Proposal for amendments to ECE/TRANS/WP.29/GRVA/2021/29

Proposal for amendments to UN Regulation No. 90 (Uniform provisions concerning the approval of replacement brake lining assemblies, drum-brake linings and discs and drums for power-driven vehicles and their trailer)

This document reflects the outcome of discussions held during the GRVA-11. The modifications to the current text of the UN Regulation are marked bold for added text and strike through for deleted text. The changes proposed to document ECE/TRANS/WP.29/GRVA/2021/29 are indicated below.

Figure 2

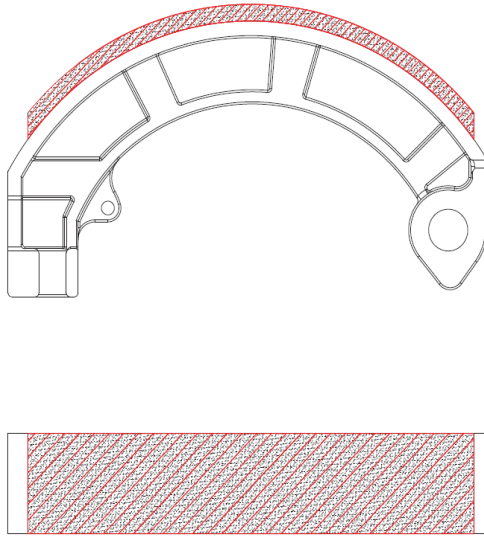
- (a) According to the individual friction material of the brake lining;
- (b) Depending on the area of the friction material area of the brake lining assembly operated by the piston/pistons of only one side of the brake caliper **or, in case of drum brakes, of only one brake shoe.**

Friction material area means all the area enclosed within the perimeter of the brake lining (see the red cross-hatched area, Figure 1, **Figure 2**), thus excluding the presence of any grooves and/or chamfers:

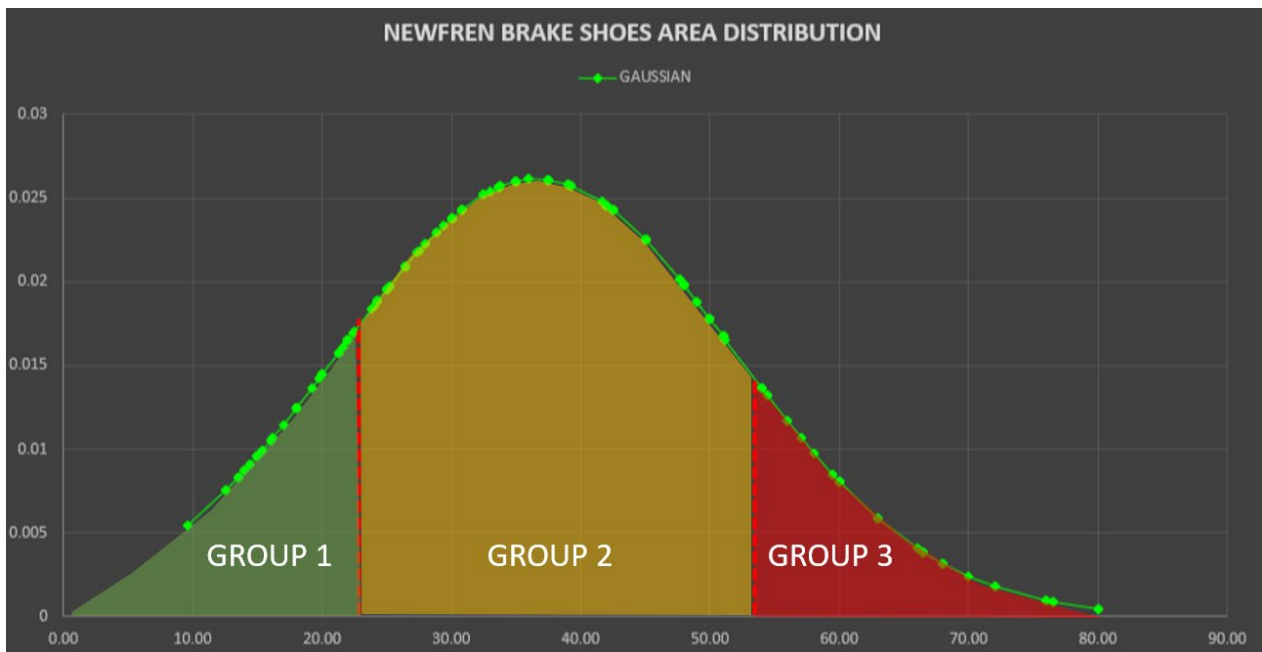
The proposed Group B (*GROUP 2 in the figure*) is centered about the average value of the areas while its amplitude corresponds to 2.00 standard deviations (Average ± 1.00 St.Dev).

It is therefore reasonable to say that all the average kinetic energy vehicles will be included in Group B, the lower energy ones will be included in Group A (*GROUP 1 in the figure*) while the high-kinetic energy vehicle will be in Group C (*GROUP 3 in the figure*).
